NO.	1
DESCRIPTION	REPLACE DC8 WITH UNBALANCED 3WAY
DATE	11/15/17
BY	W.P.
CHECKED	W.P.
SCALE	AS SHOWN
PROJECT	11800 80TH AVE N
SHEET NO.	103
TOTAL SHEETS	103

**RF MDU DESIGN
FOR BOTTINEAU RIDGE #2
11800 80TH AVE N
MAPLE GROVE MN
MNMPGR103 (D-B18-1)
JB # 189946**

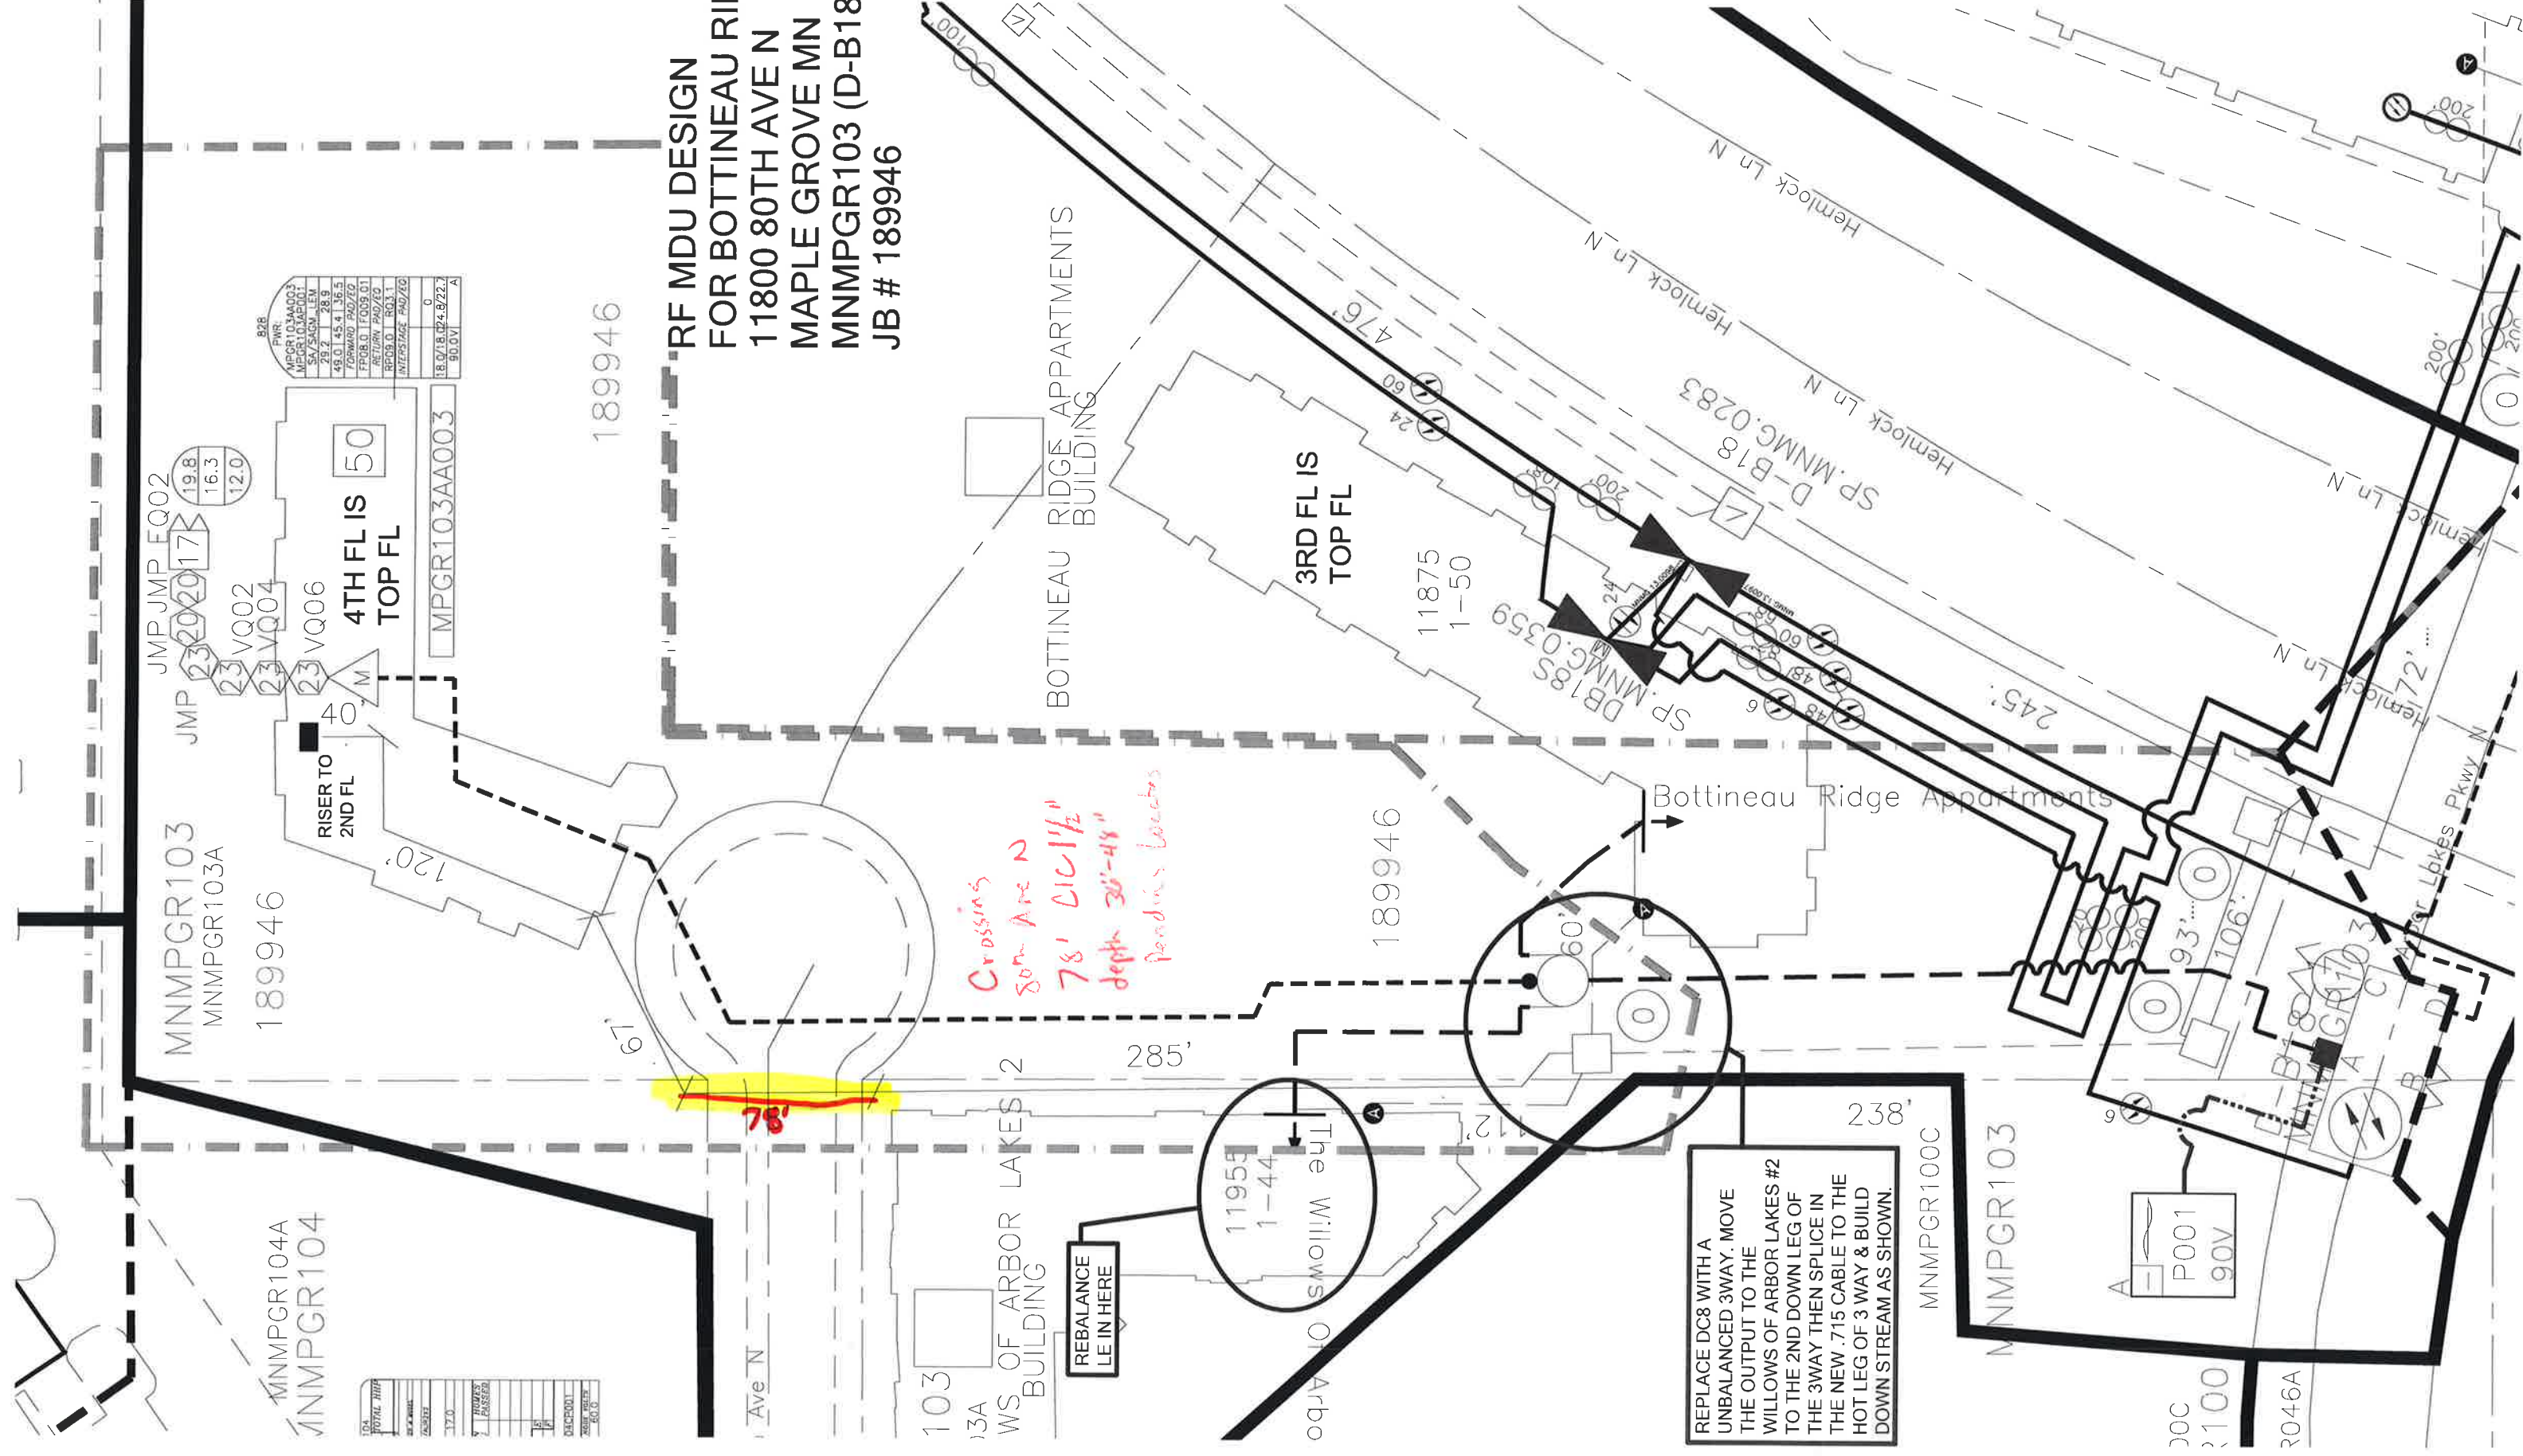
REBALANCE LE IN HERE

REPLACE DC8 WITH A UNBALANCED 3WAY. MOVE THE OUTPUT TO THE WILLOWS OF ARBOR LAKES #2 TO THE 2ND DOWN LEG OF THE 3WAY THEN SPLICE IN THE NEW .715 CABLE TO THE HOT LEG OF 3 WAY & BUILD DOWN STREAM AS SHOWN.
